M25 junction 10/A3 Wisley interchange

TR010030

9.27 Response to RHS Comments on Air Quality

Rule Number:	Rule 8(1)(c)(i)
Planning Inspectorate Scheme Reference	TR010030
Application Document Reference	TR010030/9.27
Author:	M25 junction 10/A3 Wisley interchange project team, Highways England and Atkins

Figure 4.1: Location of additional receptors in Ripley

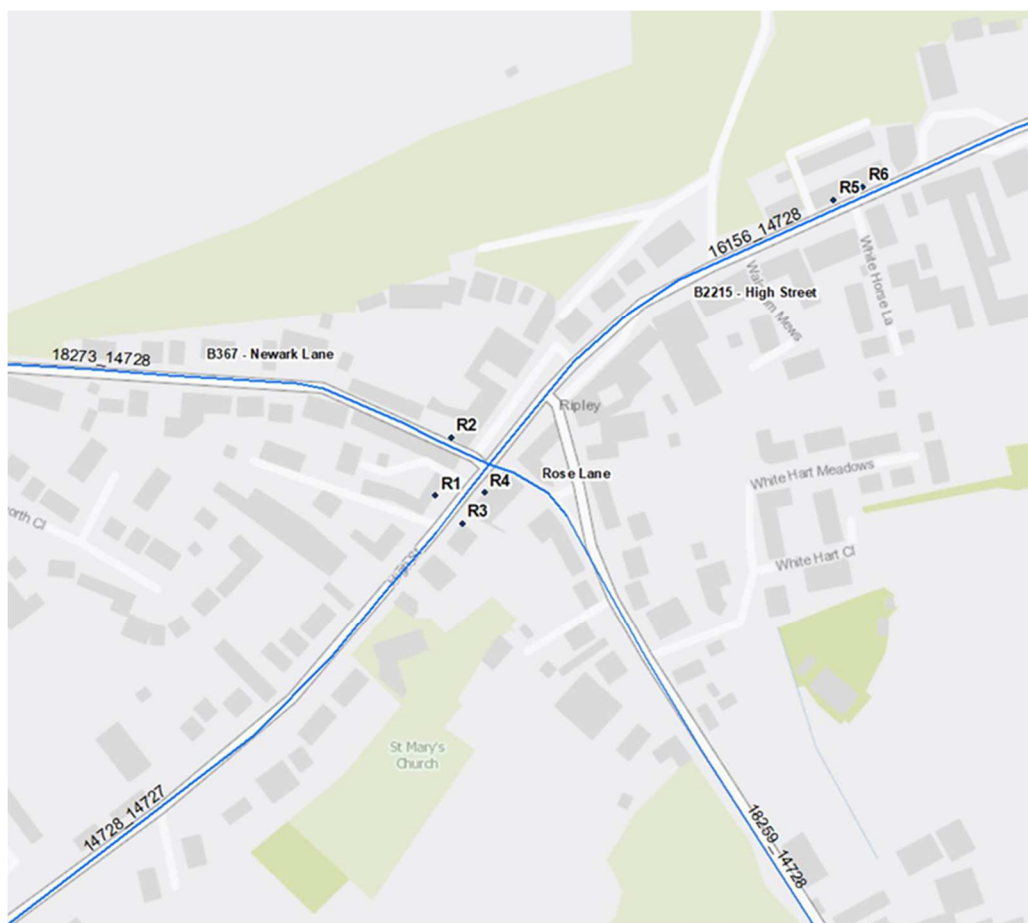
Receptors in Ripley

4.2.1 It is usual practice to include worst-case receptors in an air quality assessment. As documented in paragraph 3.13 of the DMRB (HA207/07), areas likely to experience higher-than-average concentrations, such as junctions, should be identified. The closest residential receptor to the High Street/ Newark Lane junction was therefore included in the assessment.

4.2.2 However, it is acknowledged that there are other receptors in Ripley which are closer to the kerb, although not in closer proximity to the junction. Nitrogen dioxide concentrations at residential receptors in the areas identified in REP1-041 along Newark Lane and High Street, have been modelled to determine the expected changes in annual mean nitrogen dioxide concentrations with the Scheme. These additional receptors are provided in Figure 4.1, and the results provided in Table 4.1. The largest change is expected to be a change of 0.9 $\mu\text{g}/\text{m}^3$, classified as a small increase, at a receptor on the High Street (R6).
